**CHATEL HISTORIC PRESERVATION ARCHITECT TECHNICAL MEMO,
NOVEMBER 15, 2021**

MEMORANDUM

RE San Marino Center (San Marino Women's Club)
1800 Huntington Drive, San Marino, California
Recommendations Memorandum

ATTACHMENT D:
PROPOSED PLANS
SAN MARINO CENTER (SAN MARINO WOMEN'S CLUB)

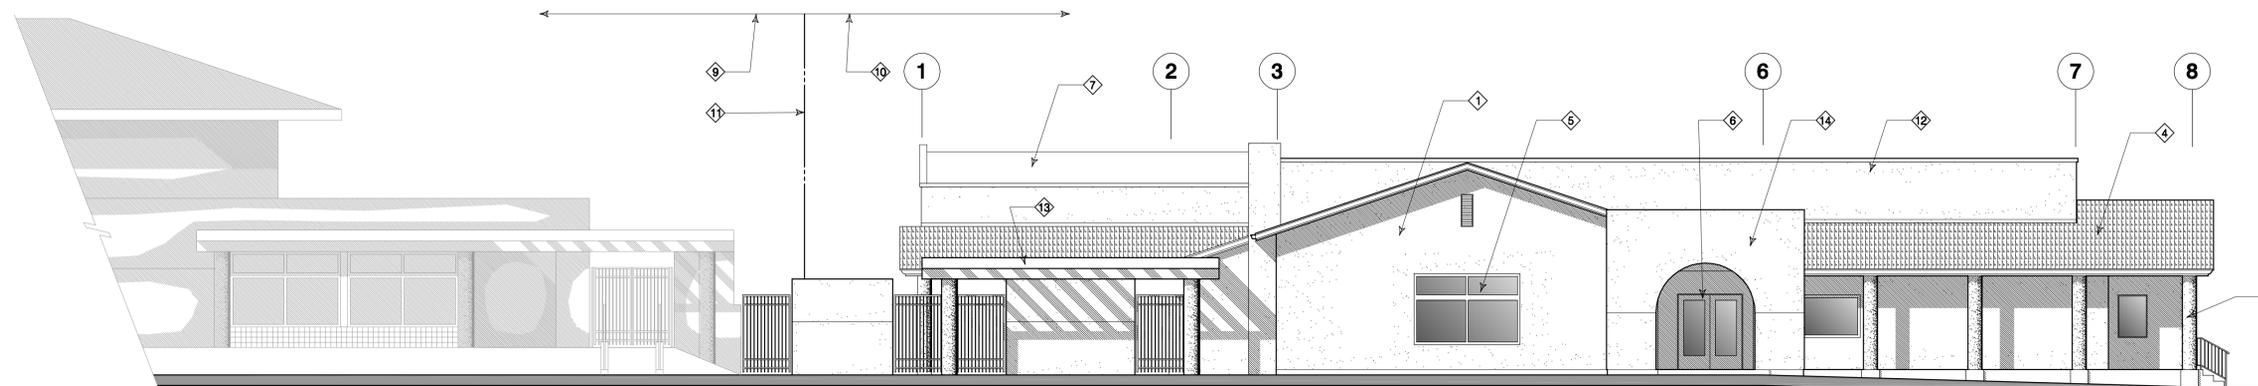
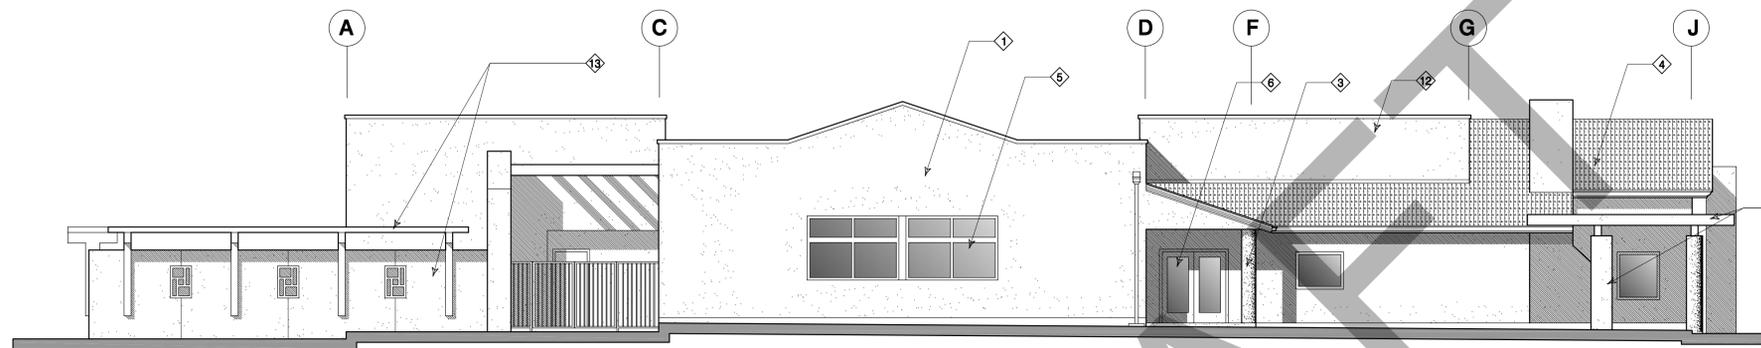
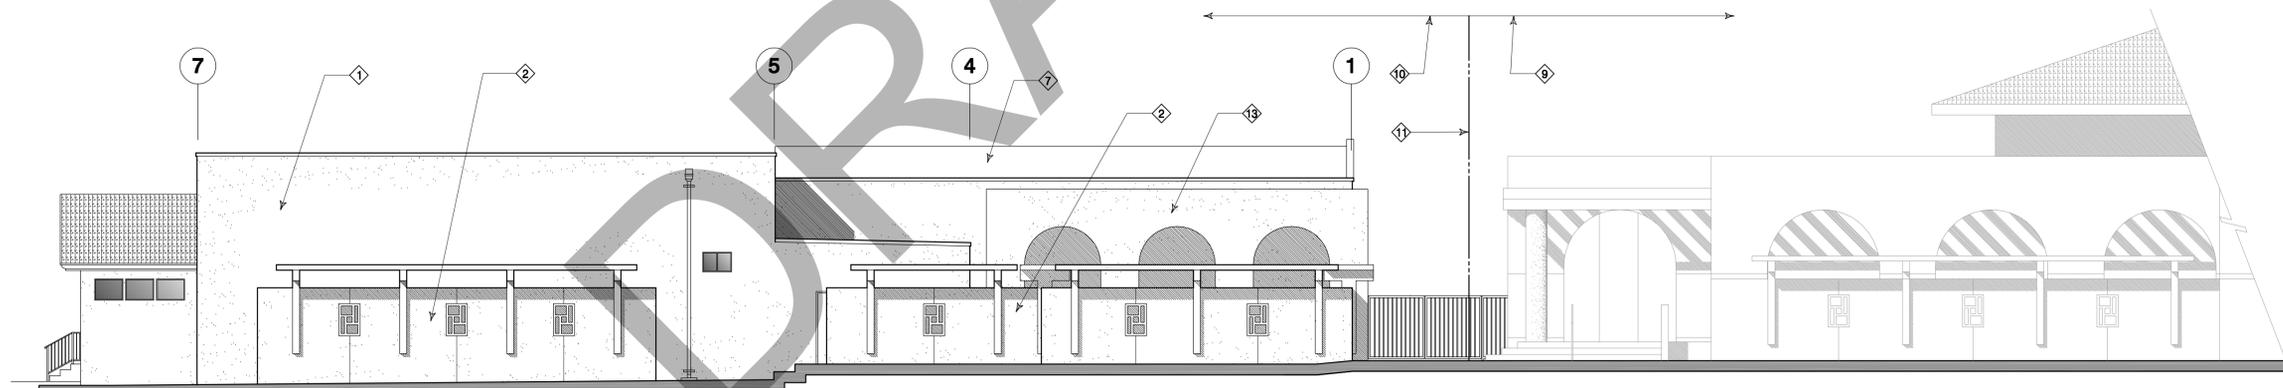
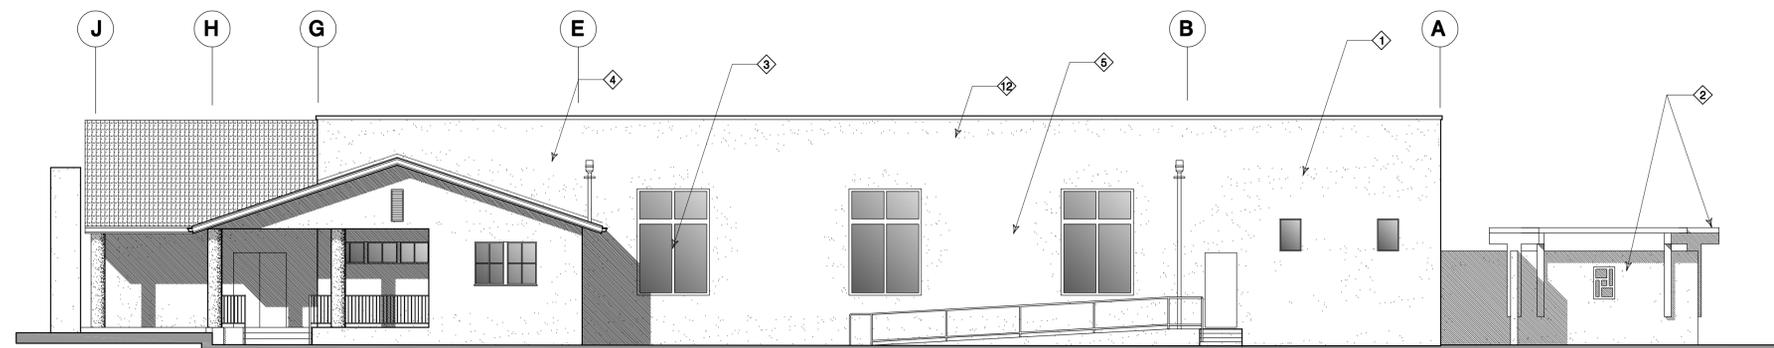
The subject property lacks some aesthetic appeal of its original design due to two additions that infilled the primary north elevation porch on both the east and west, which altered its original massing, removal of the front planter, deterioration of the exterior stucco, and weathered wood shakes. Restoring the original footprint by removing both porch additions and rehabilitating character defining features would significantly enhance the aesthetic appeal of the building.

The goal of the revised design should be first and foremost to restore and rehabilitate the subject property's character defining features while allowing for subtle changes in massing, color, and landscaping to visually connect it with the library. Visual elements of the Spanish-Mediterranean style library can be integrated into the building by subtle changes to roof color and material, exterior paint color, hardscape, and landscaping to improve compatibility with the library.

- Retain and rehabilitate character-defining features to greatest extent feasible.
- Retain wood shake roof or replace with compatible replacement such as red asphalt shingle or flat terracotta tile.

- Patch, repair and repaint stucco, as necessary. Stucco can be painted to be compatible with the library.
- Retain and rehabilitate square steel porch columns and ornamental ironwork, repaint as necessary. Columns and ornamental ironwork can be painted brown to be compatible with trim of the library.

- Rehabilitate and repair steel sash windows, as necessary.
- Retain and rehabilitate original paving, as necessary.
- Restore original planter at north elevation, match vegetation with library.

- Remove two porch additions (east storage addition and west office addition). Ensure that brick chimney is not damaged in removal of east storage addition. Chemically remove overpaint on brick.

- Detail wall and shade canopy to not touch existing building ensuring reversibility, and revise wall and shade canopy design to be subordinate to existing building. Provide only minimal metal infill at existing porch to enclose courtyard.

- Replace existing primary north entry door leaves to match existing.

- Retain and rehabilitate character-defining features to greatest extent feasible.
- Patch, repair and repaint stucco, as necessary. Stucco can be painted to be compatible with the adjacent library.
- Rehabilitate and repair steel sash and wood grid windows, as necessary.
- Remove porch addition (east storage addition). Ensure that brick chimney is not damaged in removal of east storage addition. Chemically remove overpaint on brick. Restore steel sash doors that were removed to provide access into addition.

- Retain and rehabilitate character-defining features to greatest extent feasible.
- Patch, repair and repaint stucco, as necessary. Stucco can be painted to be compatible with the adjacent library.
- Rehabilitate and repair steel sash and wood grid windows, as necessary.
- Detail wall and shade canopy to not touch existing building ensuring reversibility. Simplify design of the screen wall and trellis to eliminate round arches and detail to be self-supporting and not attached to the existing building.

- Retain and rehabilitate character-defining features to greatest extent feasible.
- Patch, repair and repaint stucco, as necessary. Stucco can be painted to be compatible with the adjacent library.
- Rehabilitate and repair sheet metal window awnings, repaint as necessary.
- Rehabilitate and repair steel sash windows, as necessary.

- Remove porch addition (west office addition). Restore missing square steel porch columns with ornamental ironwork.
